ADDRESS: 25 S VAN PELT ST

Proposal: Alter facades; construct four-story addition

Review Requested: Final Approval

(Re)Submission to the Phila
Historical Commission

West & South Elevation

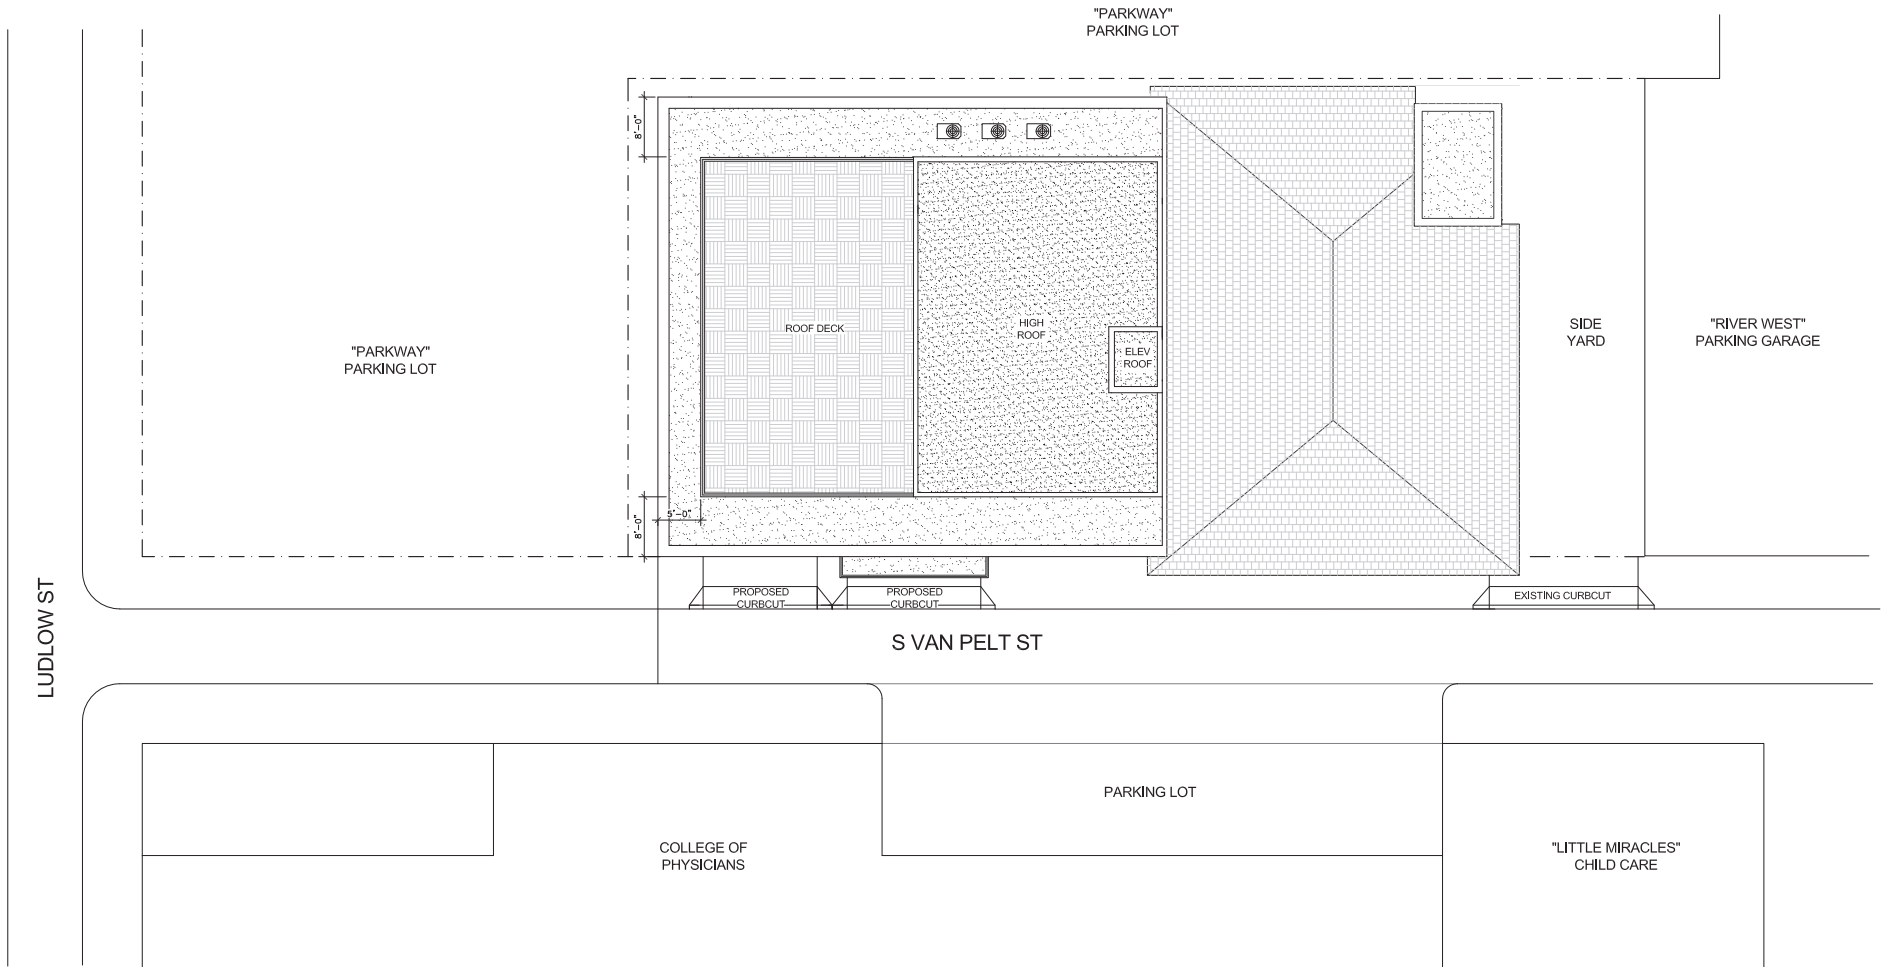
- o This application proposes to alter the number, location, and size of windows on the primary elevation of the former gymnasium building, to cut new window openings on the primary façade. Window and balcony alterations are more extensive on the new design than were proposed on the design previously approved by the Historical Commission

- o The staff realizes that the Historical Commission previously approved a garage opening on the primary first-floor façade; however, the additional garage opening further obscures the original design of the gymnasium addition.

- o The application does not comply with the Windows Guideline.
- *Standard 9: New additions, exterior alterations, or related new construction shall not destroy historic materials that characterize the property. The new work shall be differentiated from the old and shall be compatible with the massing, size, scale, and architectural features to protect the historic integrity of the property and its environment.*

- o Although the proposed addition is differentiated from the historic building it is incompatible in material and scale.
 - o The application does not comply with Standard 9.

STAFF RECOMMENDATION: Denial, pursuant to Standards 2 and 9 and the Windows Guideline.
